Amendment Date: February 11, 2008
Serial No. 10/767,833

REMARKS

Inventor: Nicola Benvenuti, et al.
Title: METHOD AND APPARATUS FOR DETERMINING
PROTECTION TRANSMISSION UNIT ALLOCATION
Attorney Docket No: 16220ROUS01U
Page 8 of 8

Figure 13

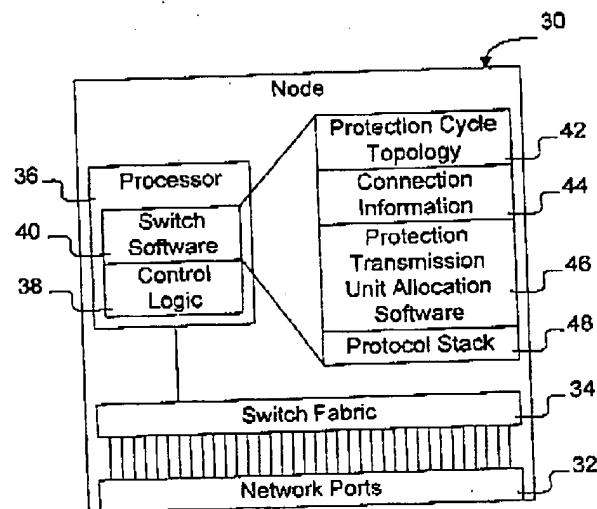
The Examiner objected to the drawings as not showing the steps of the several independent method claims. Applicants have canceled all of the independent claims with the exception of independent claim 1, and submit herewith a Drawing Correction Authorization Request to add a new Fig. 13 that illustrates the steps of this independent claim. Applicants have also added text to the specification to describe this figure by adding a new paragraph to the Description of the Drawings section and to amend paragraph 34 to add reference to Fig. 13, blocks 100, 102, and 104. These amendments are all supported by the specification as originally filed in many locations, particularly starting at about paragraph 34 and continuing through paragraph 66. Accordingly, applicants respectfully submit that these amendments do not add new matter to the application. The Examiner is respectfully requested to approve this drawing correction and amendments to the specification when acting on this Amendment.

New Figure 13
Added Here
